Village of Bayside  
9075 N. Regent Rd.  
Architectural Review Committee Meeting  
April 8, 2019  
Village Board Room, 6:00pm

**ARCHITECTURAL REVIEW COMMITTEE  
AGENDA**

Attention:  
Village of Bayside, WI  
Architecture Review Committee

<p>PROJECT/SITE OWNER: Aring Ravine LLC</p> <p>PROJECT ADDRESS: 1476 East Bay Point Rd</p>	<p>PROJECT SUMMARY: Landscaping, New Fence, Solar Array, and Play Structure</p>
--	---

5 PLAYGROUND  
NO SCALE

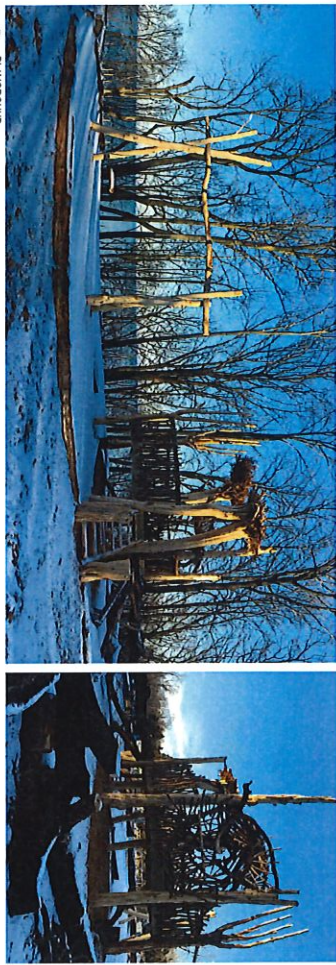
### **Play Structure:**

Regulation of children's play structures are specifically excluded from the building code. The zoning code includes the definitions for 'structure' per local chapter 125, Section 125-2: *Structure means anything constructed or erected which, for its use, requires a permanent location on the ground or attached to something having a permanent location on the ground.* Structures are regulated per the zoning code general requirements detailed in 125-3(f) and shall comply with setback requirements. The proposed play structure location is outside of the rear yard setback line as shown on the proposed site plan. The rear yard setback line was arbitrarily created based on the approximate location of neighboring homes, all of which are more than 200 feet away from the proposed play structure location. The setback requirements per 125-3(f) preclude the use of homes more than 200 feet away. As such, and considering the play structure will not be visible from the road or neighboring homes, reviewer believes the proposed location is acceptable.

### **ARC TO MAKE FINAL DETERMINATION**

Handwritten note: "Fence" with an arrow pointing to the fence drawings.

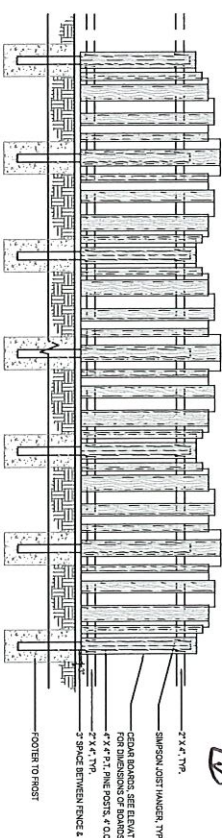
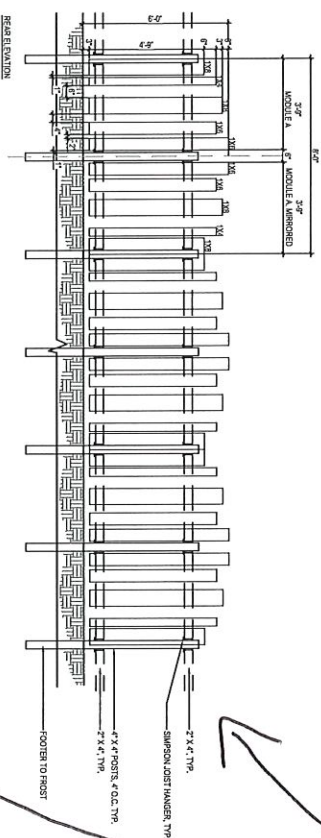
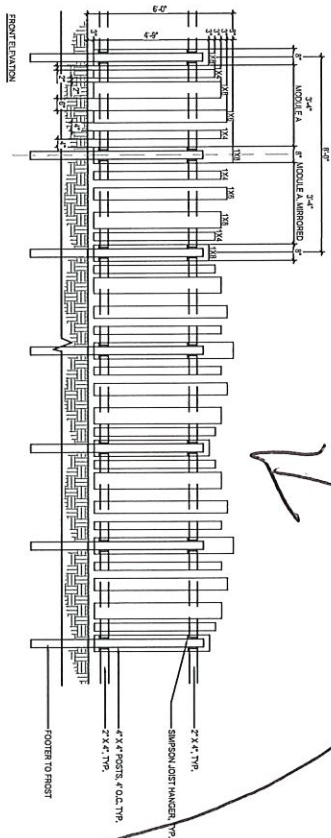
### **New Fence:**

New Fence along north property line: approximately 320 linear feet of new privacy fence. 6 ft maximum height. Approximate total property perimeter: 2,290 linear feet.

New privacy fence is approximately 14% of the total property perimeter. As such, the percentage of openness is not limited per village code section 14-125(L).

### **PROPOSED FENCE TYPE AND LENGTH COMPLY**

PRELIMINARY LAYOUT  
OF SOLAR PANELS

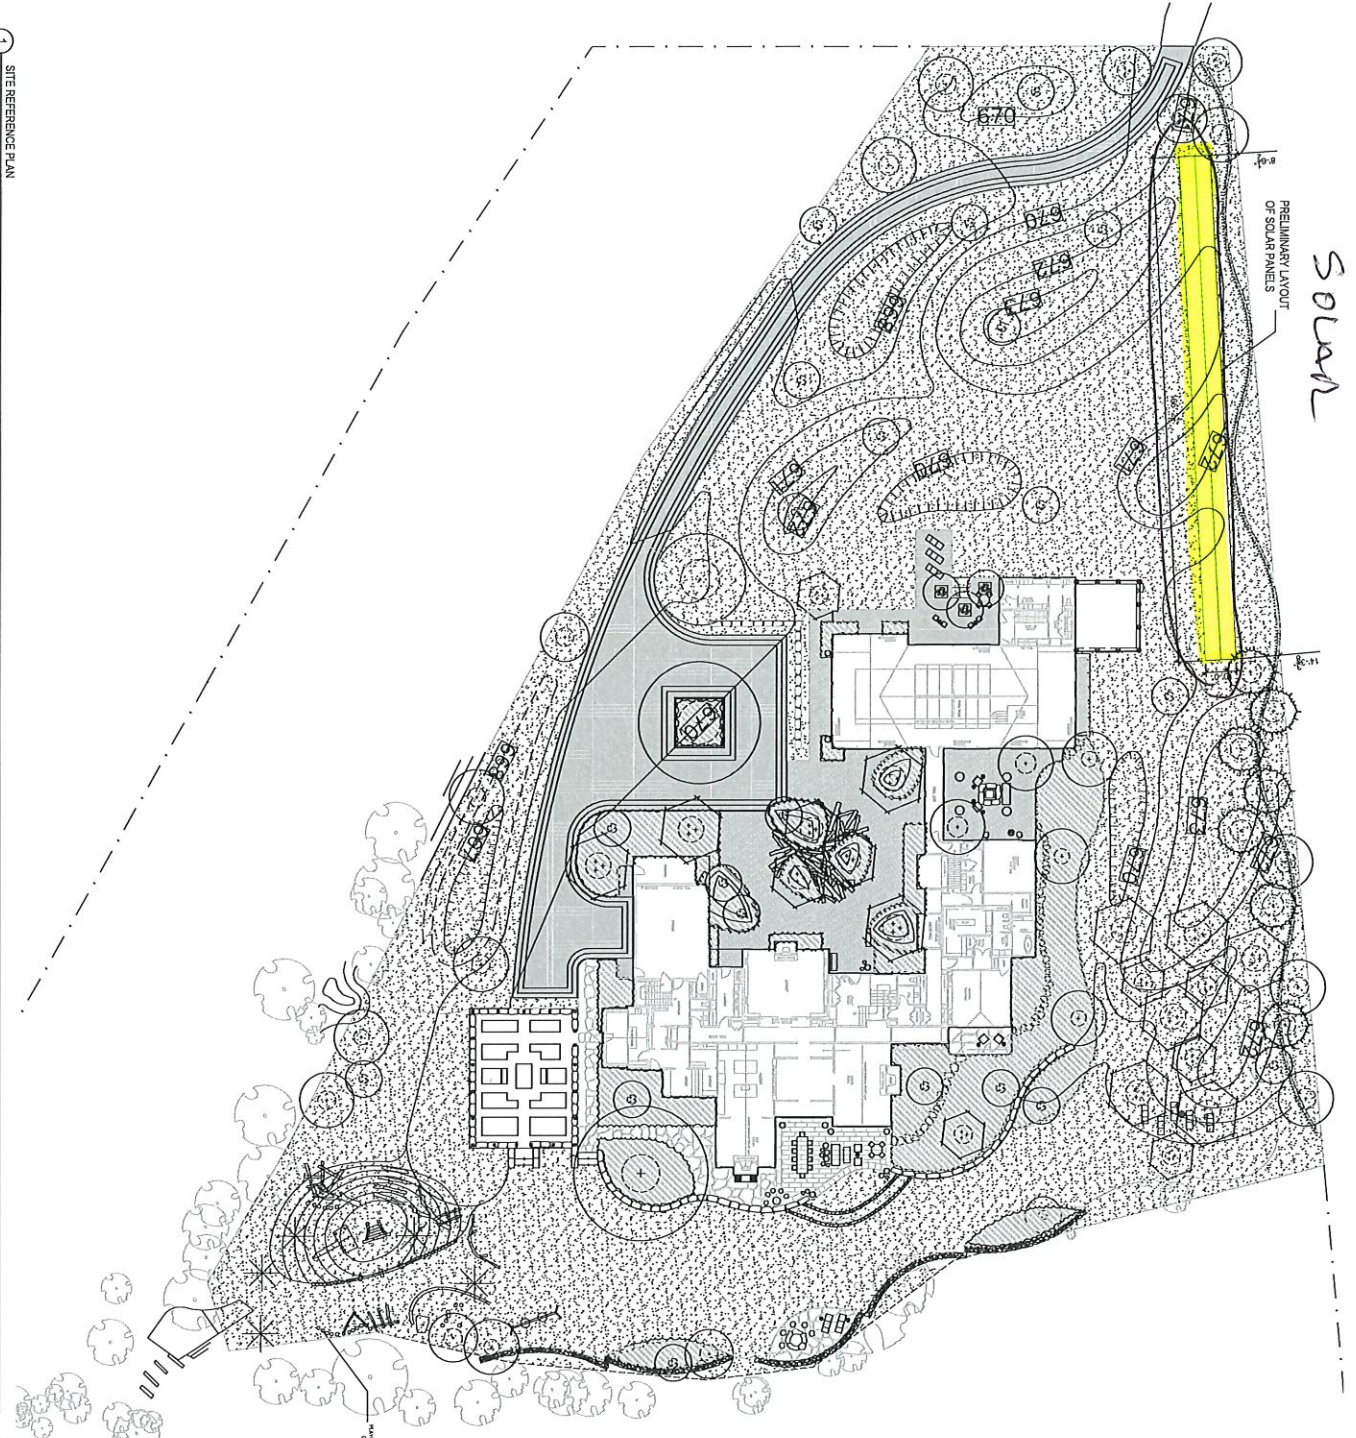
### **Solar Array:**

The solar array is not restricted by the building or zoning code and is proposed within the property's setback requirements.

You can add the solar panels to the ARC, but they have very limited ability to regulate them. See below from Chris.

### **PROPOSED SOLAR ARRAY COMPLIES**
